1 Products affected

Product Change Notification					FEC material, design and packaging change		
owner	creation date	release date	released by	change order	rev	page	D10-066-072
kraftal	22.06.2022	12.10.2022	schulejo	2022099	A	1 of 2

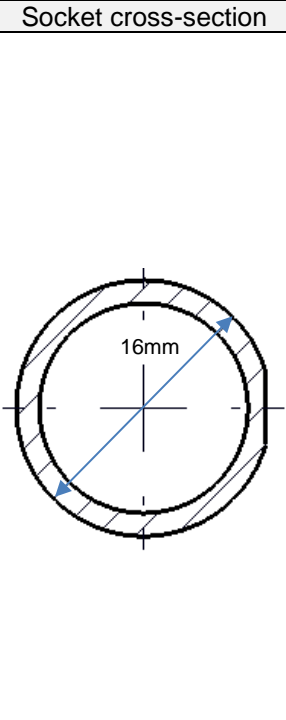
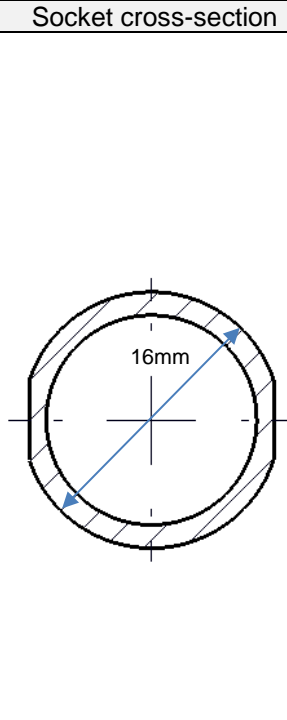
- Change of material
- Change of product design
- Change of packaging (only concerns part no. 0031.1622)

Current plastic material		New plastic material	
Thermoset PF-GF/MF FR		Thermoplastic PPA-GF FR	
Current product appearance		New product appearance	
ISO view	Socket cross-section	ISO view	Socket cross-section
		 marks/logos moved by 90°	
Current product packaging dimension		New product packaging dimension (0031.1622 only)	
cardboard box 194 x 102 x 120 mm		cardboard box 259 x 84 x 154 mm

- Replace plastic material thermoset with thermoplastic for more reliable moulding process
- Change to a modern design
- Packaging size optimized for better packaging quality
